BRITISH GLIDING ASSOCIATION RESPONSE TO THE EXETER AIRPORT AIRSPACE CHANGE CONSULTATION DATED 9th MARCH 2017

Figure 3 Exeter Airport CAS Design Concept Showing Proposed Lateral and Vertical Extents of CTA Sectors

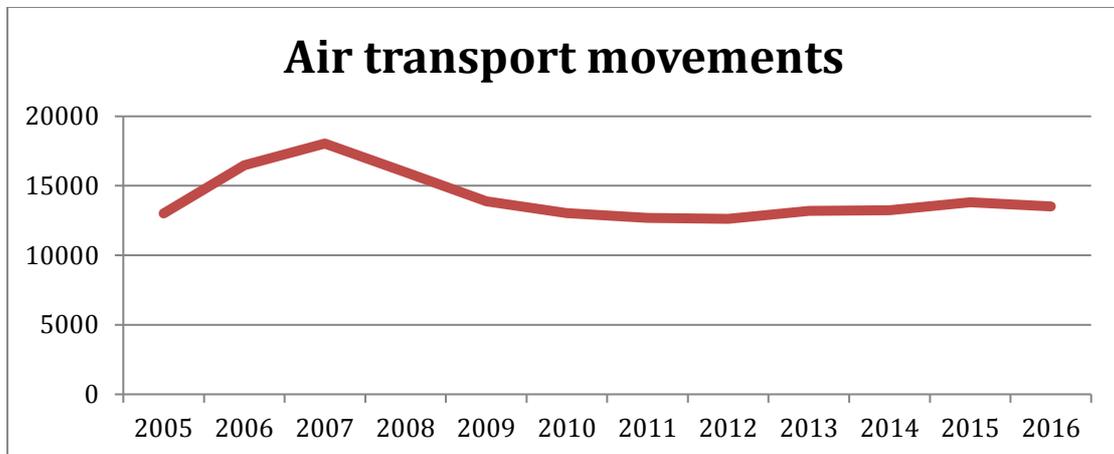
It can be seen that although distance **a** (normally associated with the most frequently used approach/runway), is more closely on a par with the proposal, Exeter's design is still nearly 3nm longer than average. This despite Exeter's requirement being less than usual due to its 3.5 degree glideslope.

All Exeter's other parameters are substantially greater than the other airports, especially the width which is over twice the average amount.

In its proposed design, Exeter has comprehensively failed its own and the CAA's criteria on efficient use of airspace and disruption of other stakeholders. Both the vertical and the horizontal extent of the proposed design are far greater than the industry norm. It is easy to understand why this approach has been taken. It is clearly cheaper and simpler for Exeter not to have to rethink the way it uses the airspace and to simply attempt to appropriate a huge area, but the consequences for gliding and other GA stakeholders will be extremely severe.

If implemented, this design would cause the unjustifiable loss of a substantial, valuable and safely used area of Class G airspace.

The BGA concludes that the proposed airspace design requires **substantial redesign**.
